# Laminate Revision

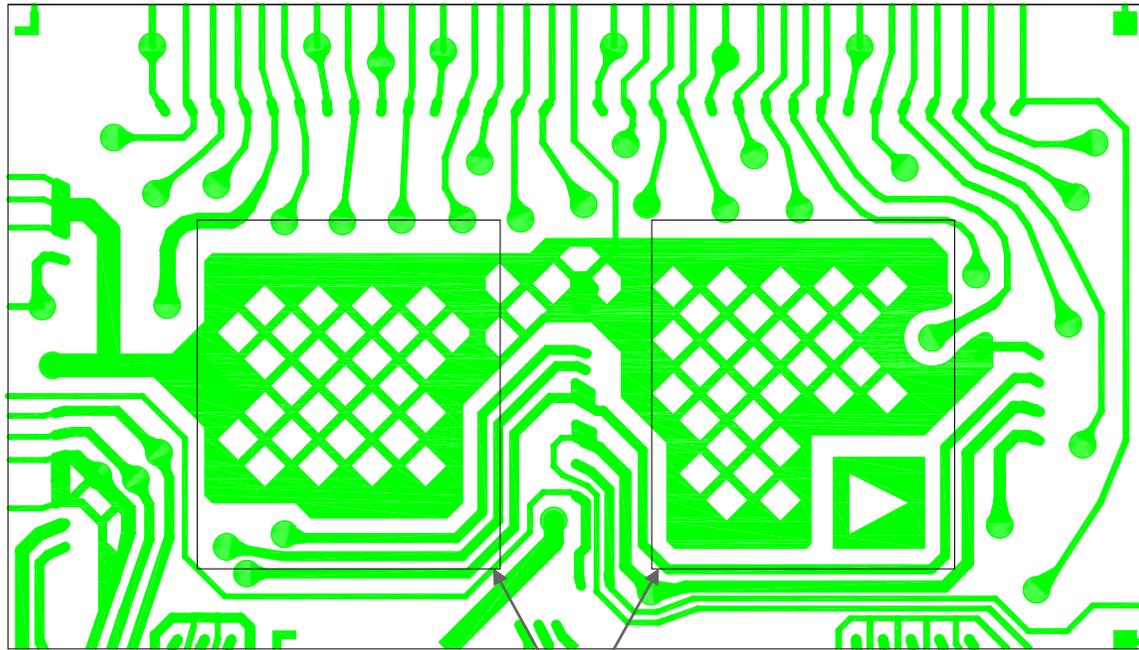
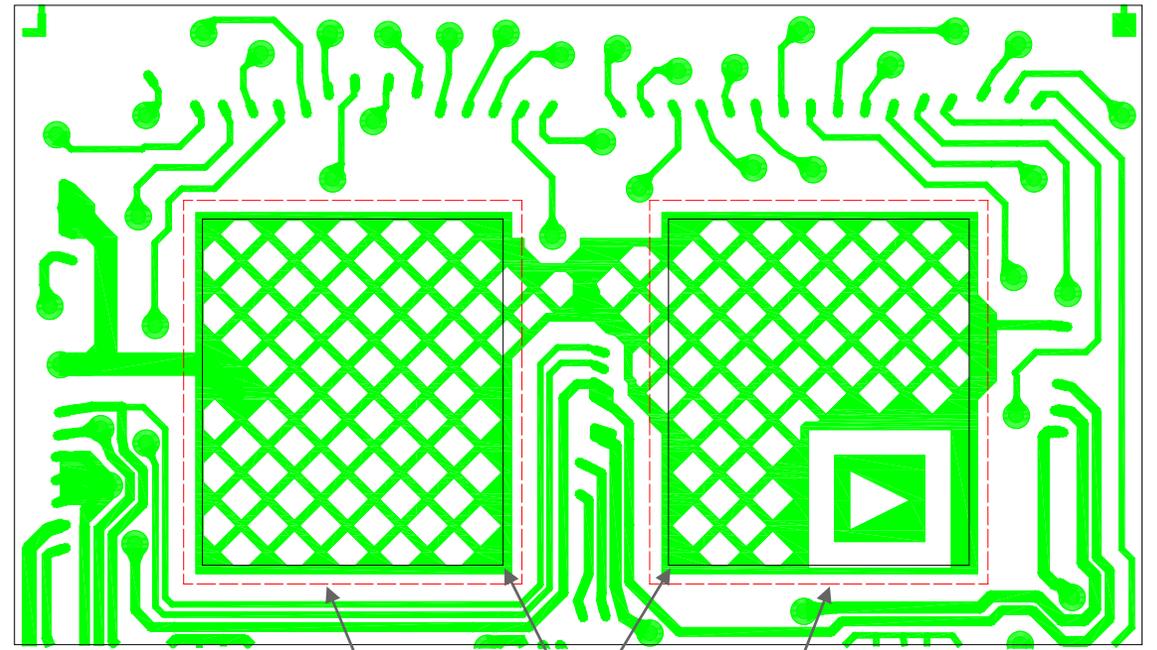
- Change: Re-routing of traces and vias from under the die area.
